May 2nd, 2022
Project No. C206-21

**RE: Final Site Plan Review – Town Memo Revisions
Terra Cotta Pasta Company (Tax Map 3, Lot 1)
52 State Road, Kittery, Maine**

**RE: Site Plan Review Application – Peer Review Revisions
Terra Cotta Pasta Company (Tax Map 3, Lot 1)
52 State Road, Kittery, Maine**

FRONT ELEVATION
 $\frac{3}{8}'' = 1'-0''$

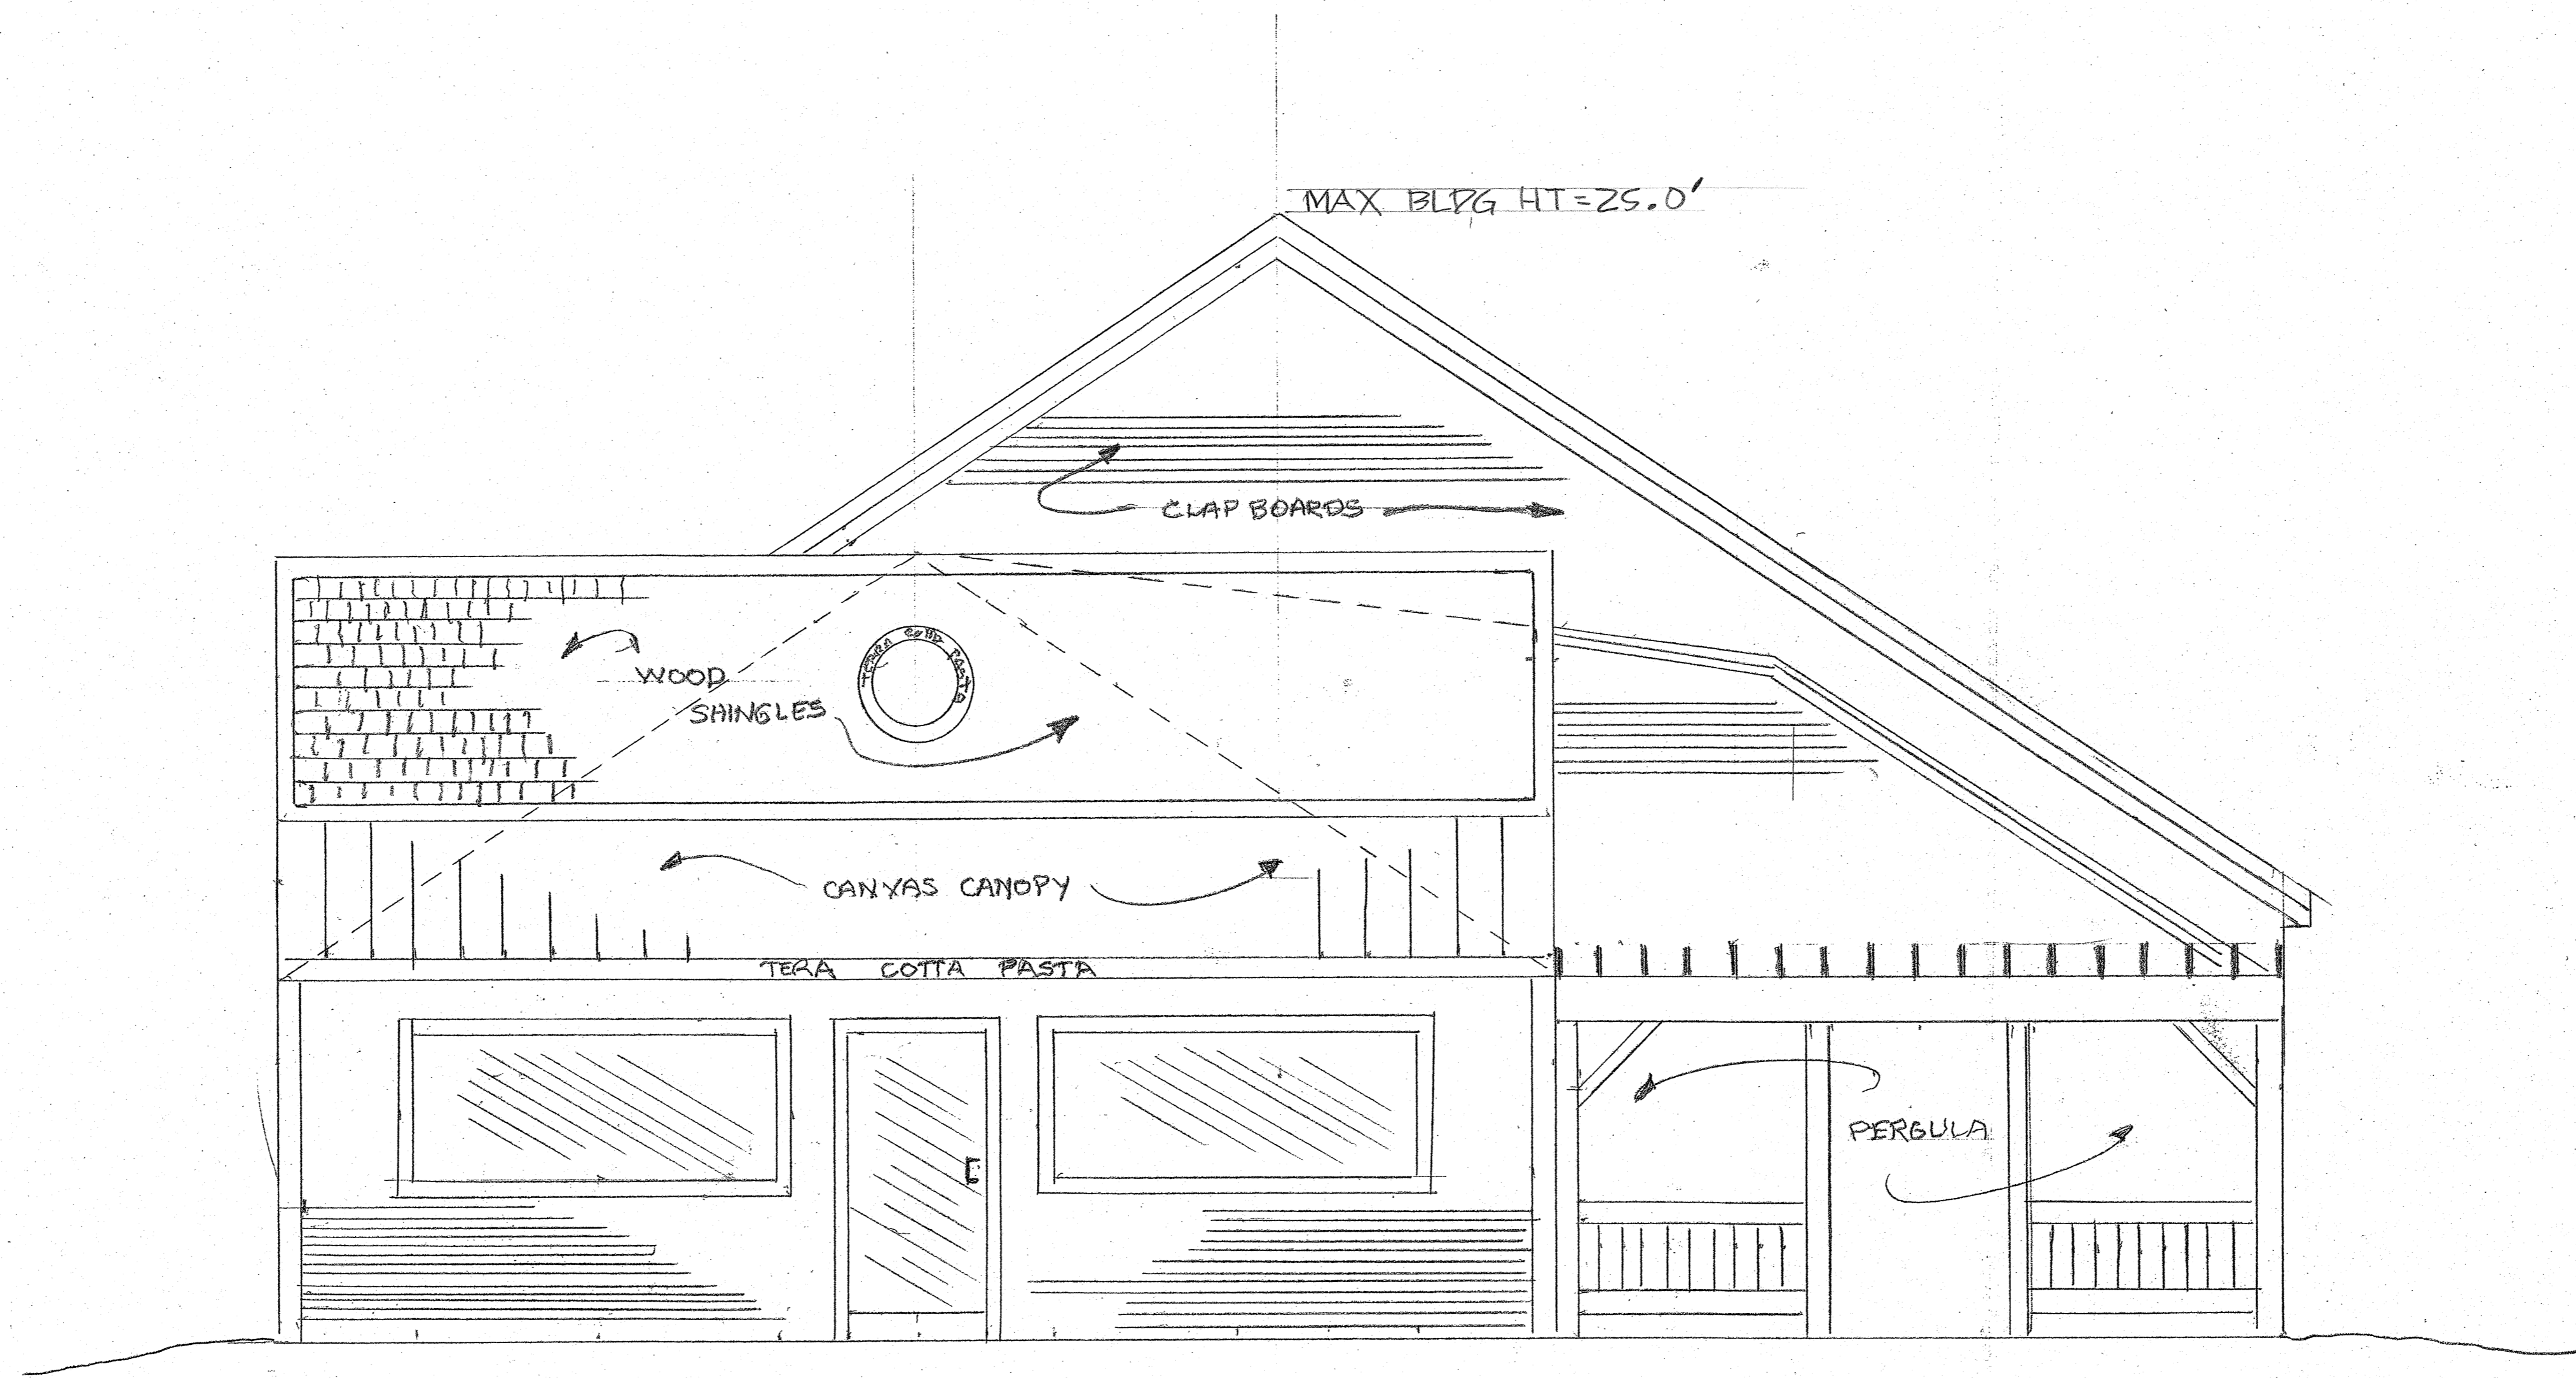
- Elevation drawings provided with the Preliminary Plan application have been attached. The attached drawing displays the proposed building materials and maximum building height of 25.0'.

OVERALL SITE PLAN
 TERRA COTTA EXPANSION
 STATE ROAD, KITTERY, MAINE

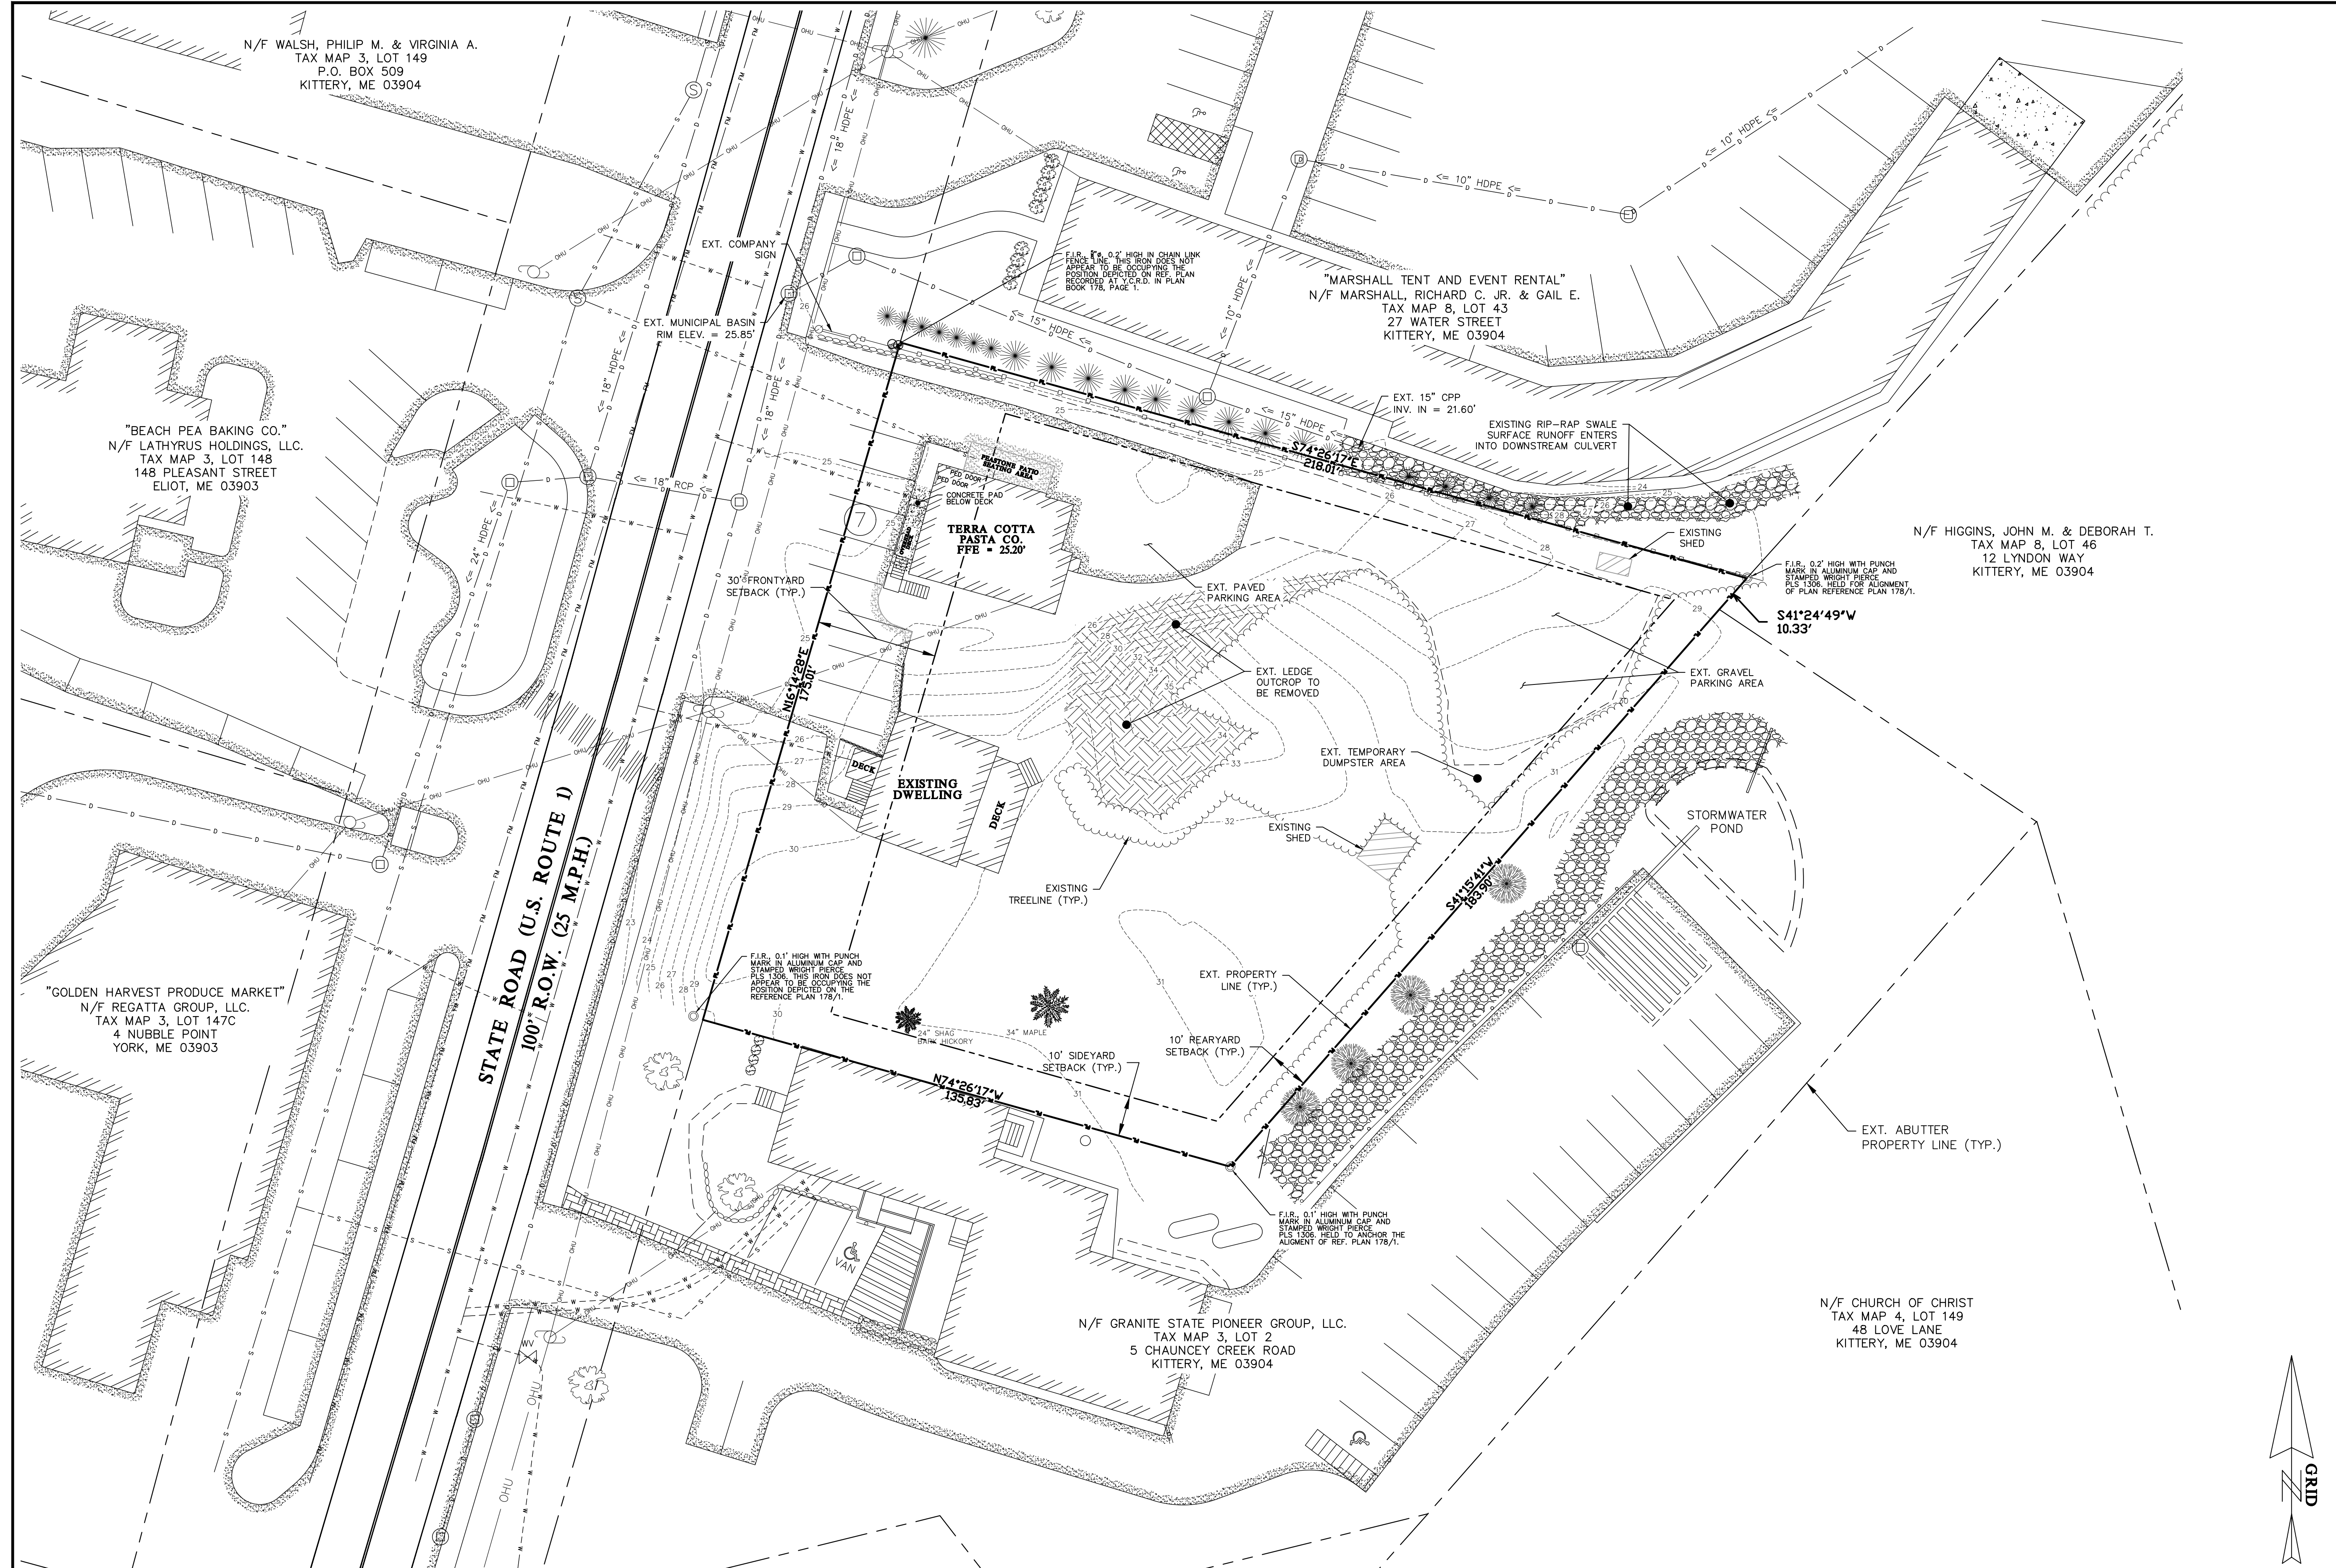
- Sheet 1 has been revised to include a callout noting the subject parcel, tax map and lot information, and lot size. Sheet 1 has similarly been revised to include widths and dimensions of the proposed travelway and pergola.

- General Note #3 on Sheet 1 has been revised to include the existing frontage for the lot of 175.01' as per Plan Reference 1. Said Plan Reference (Boundary Survey prepared by Wright-Pierce Engineers) is also attached.

- General Note #10 on Sheet 1 has been revised to state the existing hours of operation, which shall remain unchanged through the proposed development.
